# SERVICE BULLETIN # 1003

SUBJECT ~~Gear Case Protector~~

~~Use of two (2) instead of one (1)~~

MODEL 55 DATE 9-20-57

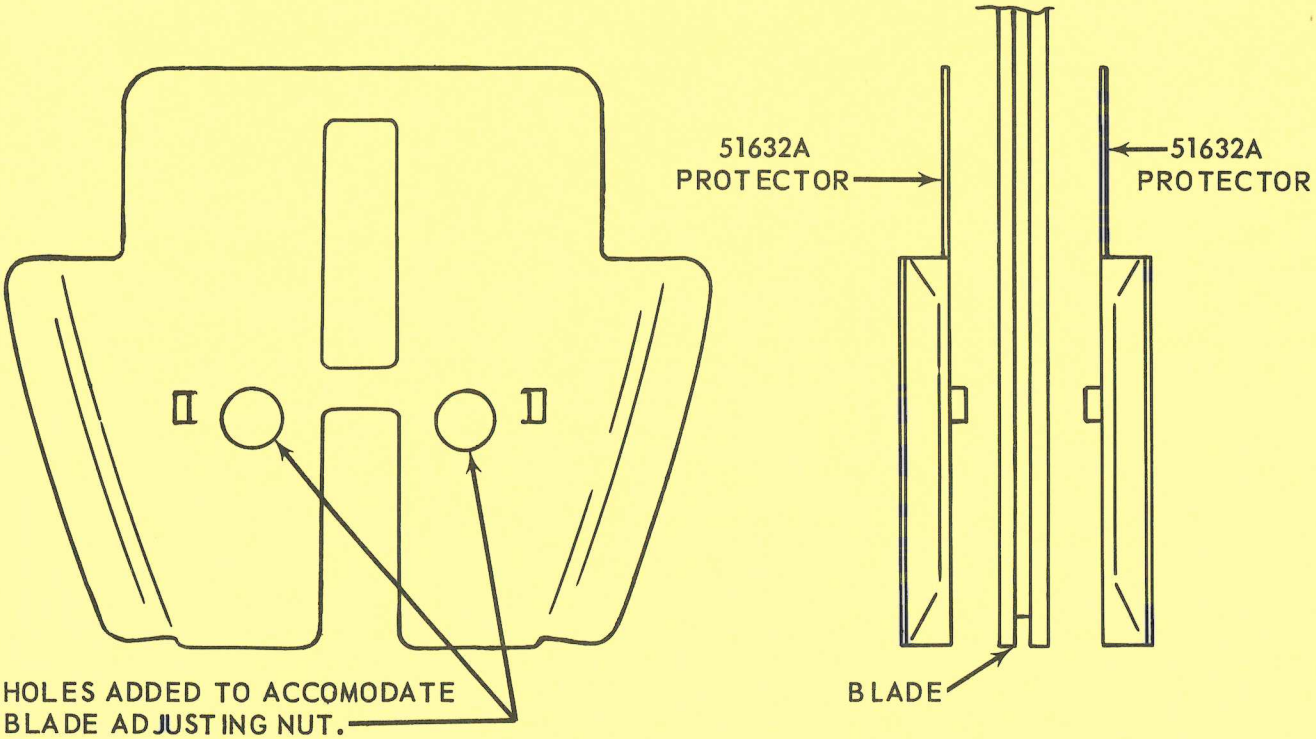
Beginning with serial number 6000, Model 55 Chain Saw engines shipped from the factory are equipped with two (2) gear case protectors, part number 51632A. The protectors, which have been redesigned to accommodate the lockplate adjusting nut, should be installed on both sides of the blade. (See Illustration.)

By installing the protectors in this manner, chain oil is retained within the blade grove, thus insuring a controlled flow of oil to the chain.

Two gear case protectors can be utilized on early Model 55 Chain Saw engines, providing the protector installed on the outer side of the blade is the new style, part number 51632A.
